## 20-105PDP & 20-106FDP-CU – CHASE BANK

This is a request for review and approval for a Preliminary Development Plan/Final Development Plan and a Conditional Use for the construction of a new bank located on a ±0.84-acre site located within the Bridge Street District (BSD).

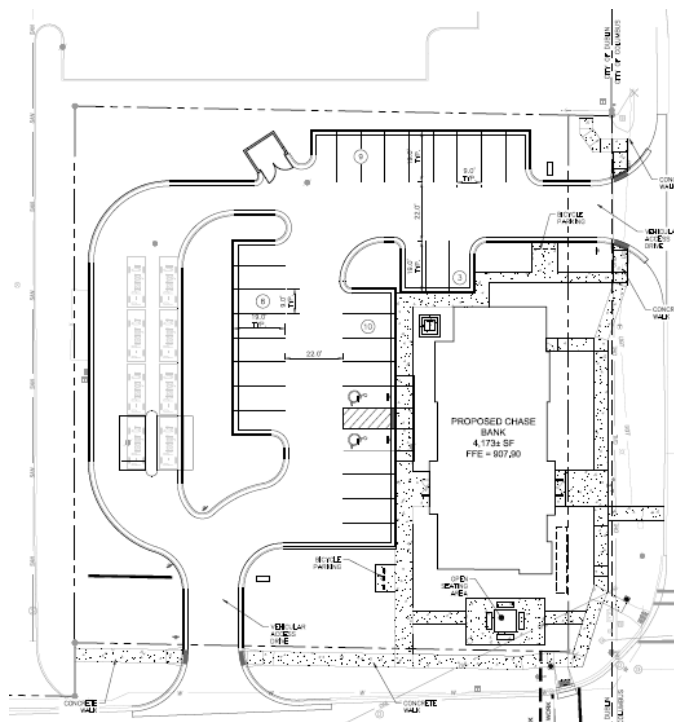
The site has two vehicular access points: a right-in/right-out curb cut along Sawmill Road, and a full access curb cut along Banker Drive. The applicant is proposing to modify the size of the vehicular access point on Sawmill Road and move the access point to the west of the existing location to align with the Piada access point to the south of the site. Sidewalk access is proposed to extend along both frontages, as well as extending pedestrian access from the sidewalk to the main entrance of the building and to a proposed dedicated open/seating area.

Since the Concept Plan application in May, the applicant has worked with staff to relocate the proposed open space to the corner of the site, resulting in the movement of the proposed building north of its original location. This relocation was to aid in the creation of a 'Gateway Feature', which will be discussed later in this report.

The applicant is proposing a drive thru ATM located west of the building along the western property line. 'Drive-in/Drive-through' uses within the Bridge Street District – Sawmill Center Neighborhood are considered conditional uses. The ATM has two lanes for access with four stacking spaces each. The vehicular canopy is 12 feet – 10 inches in height and is constructed of a metal canopy in the color Silver "Chase", and is held by four brick pillars in a platinum color. Planning Staff recommends that the protective bollards surrounding the ATM be painted platinum

to match the brick pillars. Since the ATM access lanes are facing a non-principal frontage street to the south, the applicant is proposing a 3 feet – 7 inch tall street wall between the access lanes and the street to screen the ATM area. Bridge Street Code allows for a maximum of 3 feet in height for street walls. The applicant should revise the street wall design to meet the maximum height.
